UNITED STATES PATENT AND TRADEMARK OFFICE

APPLICATION NO.	FILING DATE	FIRST NAMED INVENTOR	ATTORNEY DOCKET NO.	CONFIRMATION NO.
09/806,031	03/26/2001	Rabah Arhab	1200.465	3435

Office Action Summary

Fig. 8

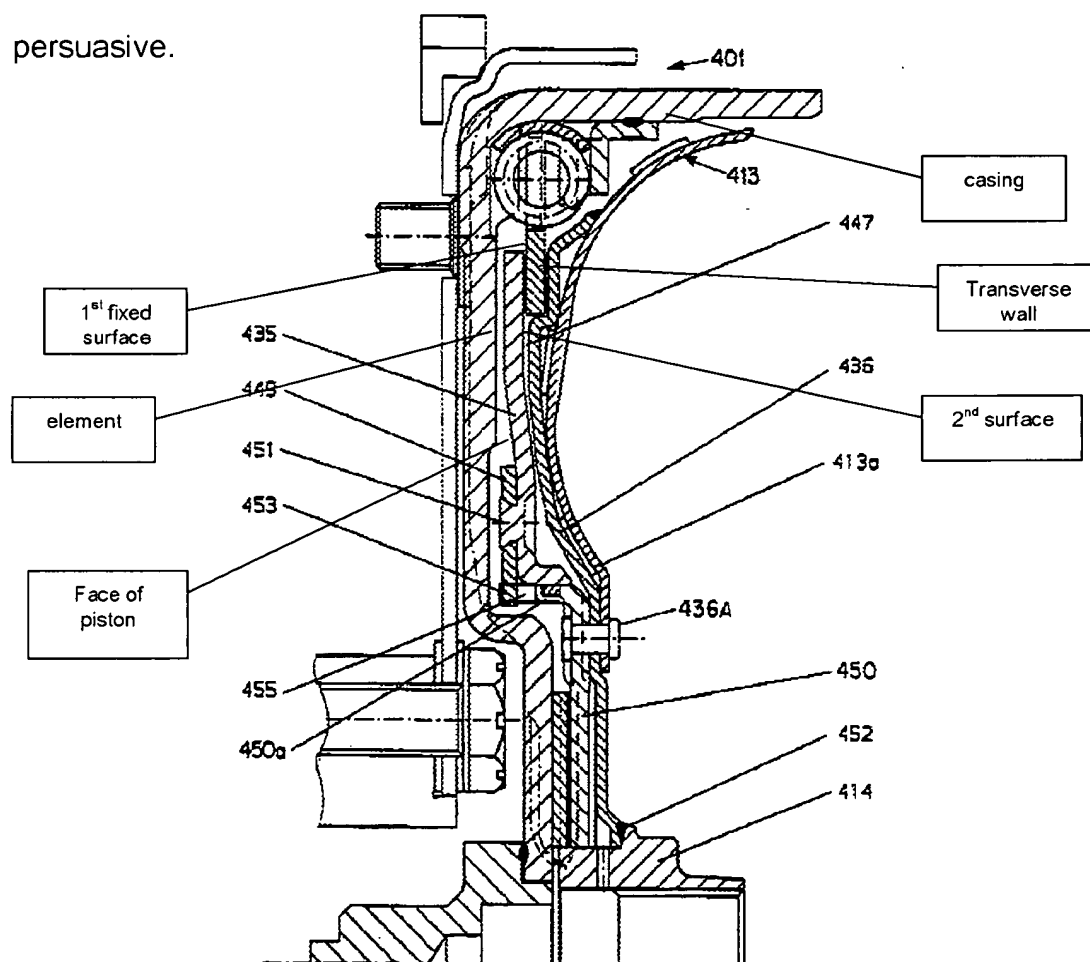
Re: claims 1, 2, 5 and 20. Friedmann et al. show in figure 8 a hydrokinetic coupling apparatus for a motor vehicle comprising a casing as labeled by Examiner in the copy of figure 8 provided in the Response to Arguments section of this Office Action having a transverse wall as labeled and adapted to be coupled in rotation to a driving shaft, a turbine wheel 413 mounted within the casing and fixed to a hub 414,450 which is adapted to be coupled in rotation to a driven shaft, a fixed first surface as labeled on the transverse wall of the casing, and a lock-up clutch as shown interposed between the turbine wheel and the transverse wall and comprising a piston 435 carrying a second surface as labeled which lies facing the first surface capable of coupling it releasably to the transverse wall as the piston reciprocates axially, wherein a friction means 449 acts between a face of the piston as labeled opposed to the second surface and an element situated in facing relationship, characterized in that the piston is so configured as to carry the friction means as shown via element 451.

Re: claims 26, 27, and 28. Friedmann et al. show in figure 8 a hydrokinetic coupling apparatus for a motor vehicle comprising a casing as labeled by Examiner in attached copy of figure 8 having a transverse wall as labeled and adapted to be coupled in rotation to a driving shaft, a turbine wheel 413 mounted within the casing and fixed to a hub 414,450 which is adapted to be coupled in rotation to a driven shaft, a fixed first

surface as labeled on the transverse wall of the casing, and a lock-up clutch as shown interposed between the turbine wheel and the transverse wall and comprising a piston 435 carrying a second surface as labeled which lies facing the first surface capable of coupling it releasably to the transverse wall as the piston reciprocates axially, wherein the turbine wheel 413 includes an annular ring 413a which may be of divided form as best understood and which is fixed to the hub by means of a rivet 436a, and wherein a friction means 449 acts between the hub and the piston, characterized in that the piston is so configured as to carry the friction means as shown via element 451.

As shown in the copy of figure 8 in the previous page, Fiedmann et al. shows a fixed first surface on the transverse wall of the casing, portions of a lock-up clutch shown interposed between the turbine wheel and the transverse wall, the piston carrying a second surface which lies facing the first surface capable of coupling it releasably to the transverse wall as the piston reciprocates axially via element 455 wherein the friction means acts between a face of the piston opposed to the second surface and an element or a second transverse wall of the casing situated in facing relationship. Examiner maintains that, as broadly claimed, element 449 is a friction means as the portions 453 of element 449 are made such that they are free to move in sockets or recesses 455 in which the portions 453 are received. Accordingly, the rejections based on Friedmann et al. are maintained.
